PL207-2018 222 St John St - MMC Parking Garage: Street & Streetscape Preliminary Comments

The following are my Preliminary Comments on the plans (dated 6/22/18) for the proposed MMC Parking Garage. Additional comments are likely.

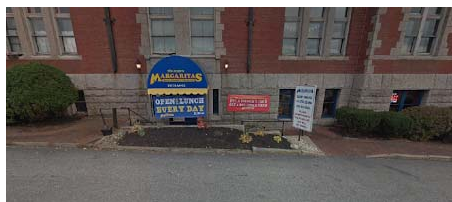
- A crosswalk across the Margarita's driveway should be provided
- A continuous sidewalk along the frontage of Margarita's should be provided - there should be an expectation of some pedestrian use of that route to/from the 1st floor of the parking garage connecting to St John St.
